**Subject: Dresden Unit 2 - Amendment No. 3 to the  
 Full-Term Operating License Application,  
 AEC Dkt 50-237**

DRESDEN STATION UNIT 2

AMENDMENT NO. 3

(Response to AEC Questions Dated February 22, 1974)

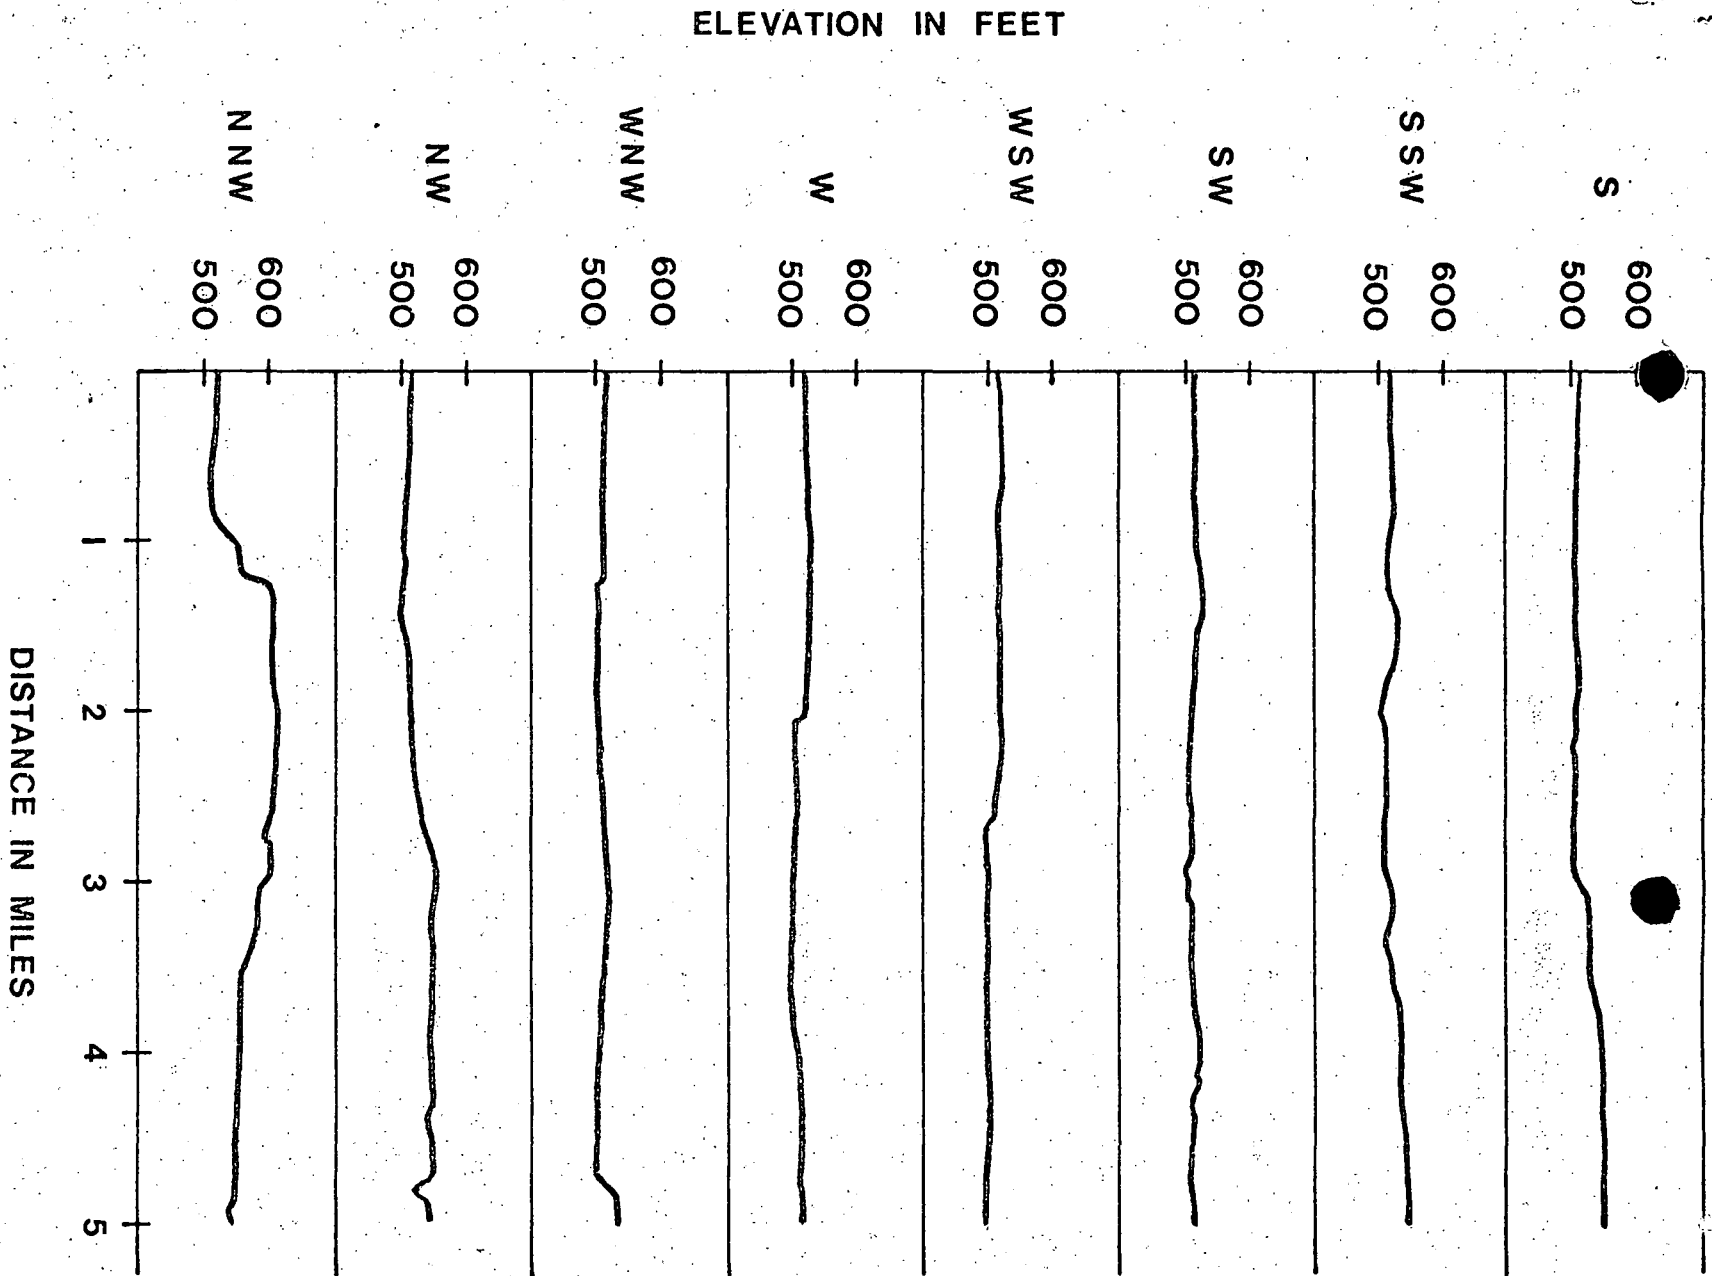
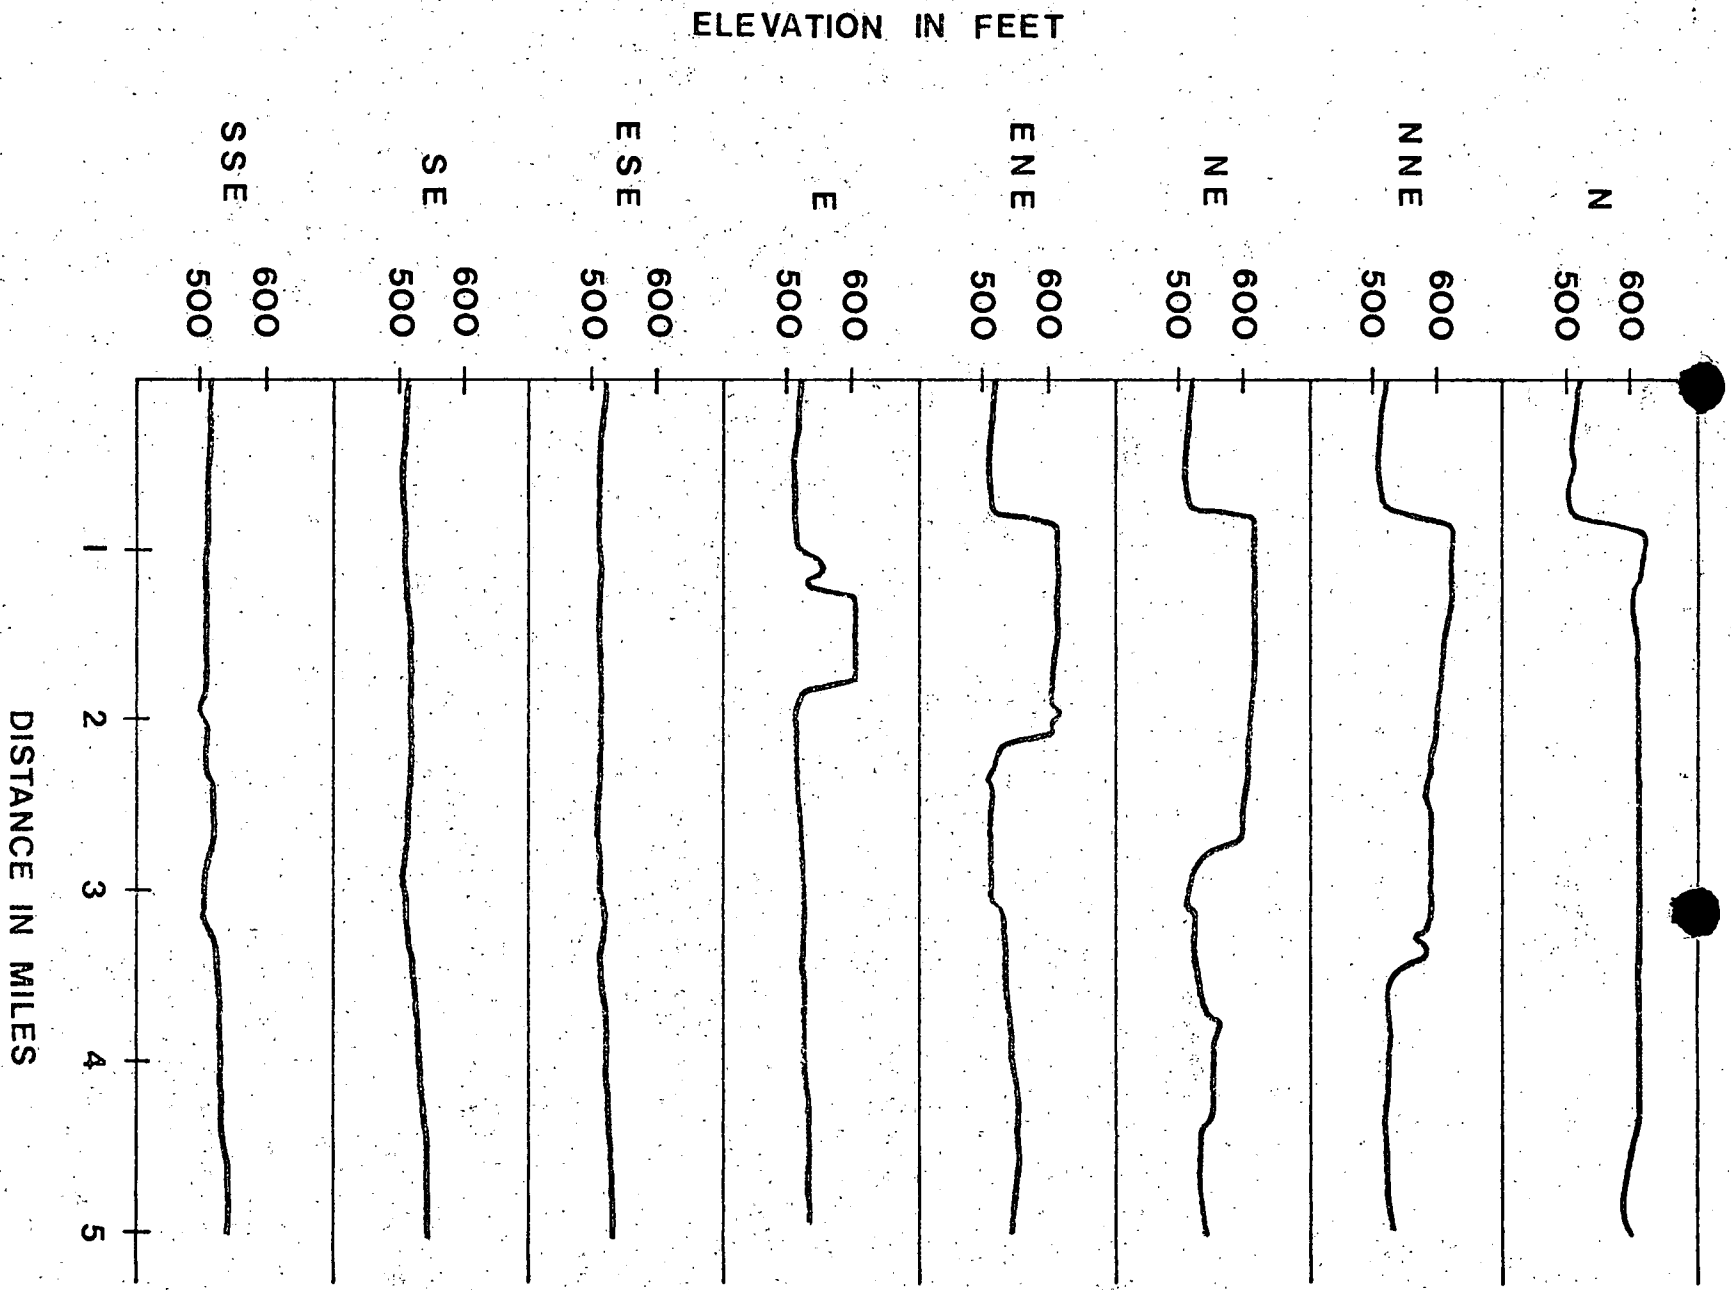
Question 3. Provide topographic cross sections in the 16 compass point sectors radiating from the plants to a distance of five miles.

Response. The required information is shown on the attached two sheets.
